Access Compliance Report

Public Rights-of-Way

(Curb Ramps)

Intersection ID: 25211	Main Street: SMITH_RD	Cross Street: SOUTHBRIDGE_FOREST_DR	Location: NW
ADA ID: DEAA81190FD7	Ramp Type: Perp	Initial Pass/Fail: Fail	Overall Compliance: No
		Severity Score: 10

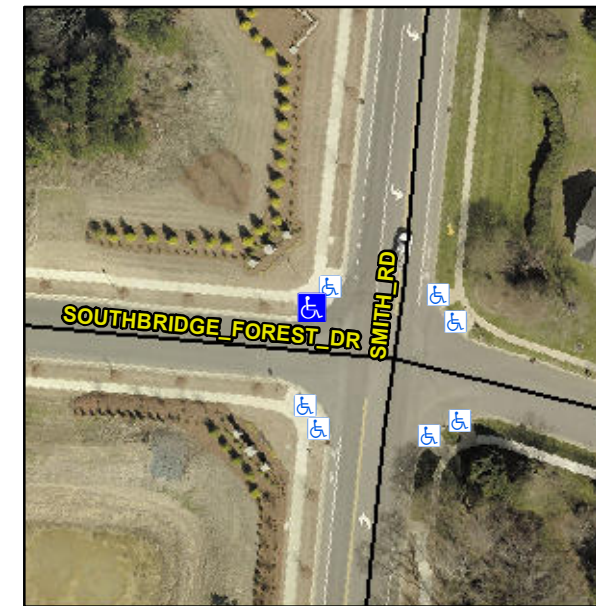
R304.5.1, R304.5.3

Compliance	Description	Data	Compliance	Description	Data
N/A	Ramp Length (in)	95.0	Yes	Ramp Slope (%)	6.2
No	Ramp Width (in)	46.5	No	Ramp XSlope (%)	2.5
N/A	Flare Type LT	N/A	N/A	Flare Type RT	N/A
N/A	Flare Slope LT (%)	N/A	N/A	Flare Slope RT (%)	N/A
N/A	Flare Traversable LT?	N/A	N/A	Flare Traversable RT?	N/A
N/A	Landing Length (in)	N/A	N/A	DWS Provided?	N/A
N/A	Landing Width (in)	N/A	N/A	DWS Contrast?	N/A
N/A	Landing Slope (%)	N/A	N/A	DWS Length (in)	N/A
N/A	Landing X Slope (%)	N/A	N/A	DWS Full Width?	N/A
N/A	Landing Curb? (Y/N)	N/A	N/A	DWS Offset (in)	N/A
N/A	Shared Landing?	N/A			
N/A	Gutter Ponding?	N/A	N/A	Gutter Slope (%)	N/A
N/A	Gutter Lip Ht (in)	N/A	N/A	Gutter X Slope (%)	N/A
N/A	Painted X Walk1?	No	N/A	Painted X Walk2?	N/A
	X Walk 1 Direction	To SW		X Walk 2 Direction	N/A
N/A	X Walk 1 Width (in)	N/A	N/A	X Walk 2 Width (in)	N/A
	X Walk 1 Slope (%)	0.7		X Walk 2 Slope (%)	N/A
	X Walk 1 X Slope (%)	2.1		X Walk 2 X Slope (%)	N/A

Remove & Replace Entire Ramp.
